Product Support Bulletin 2013-002

Maintenance of Way ~ Work Equipment Bulletin

SUBJECT: Remote Power Controllers (RPC's) used in all PLC Logic Boxes.
(Nordco P/N 5129100, 5129105 and 5129110)

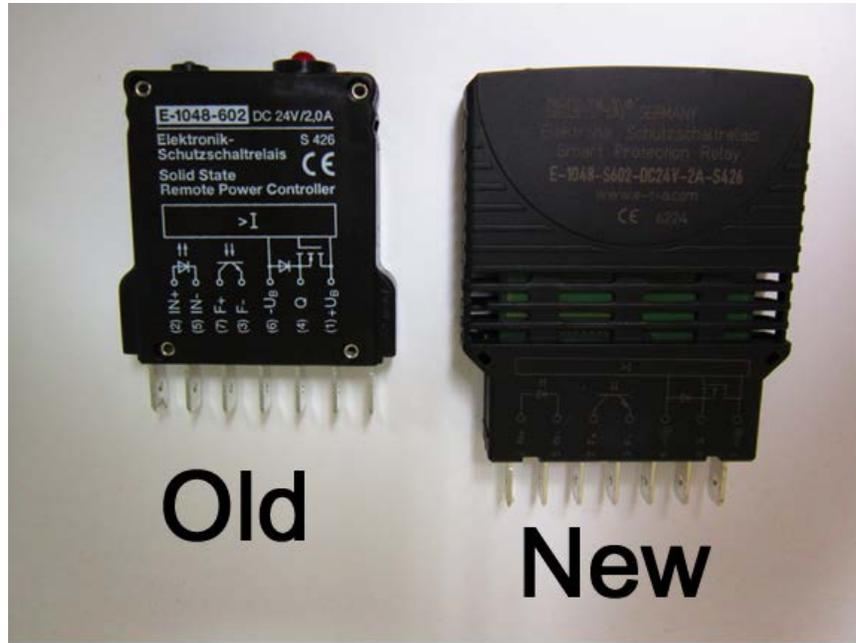
SUMMARY: The manufacturer has discontinued production of their E series (-6XX) Remote Power Controllers and replaced them with the E series (-S6XX). The new style RPC is physically larger than the discontinued style RPC and requires a different clip to hold in place.

OPERATIONAL IMPACT: None. The new RPC will plug right into the existing base and the new clip will also fit the same as the old one.

ACTION: If your old RPC goes bad you will need to purchase a Nordco Kit for that part number (amp rating) of the RPC you are replacing. The table below lists the old numbers as well as the new numbers. The Kit P/N's listed below will include the new RPC and new clip. After the purchase of the kit, the new RPC's and clips can be purchased individually.
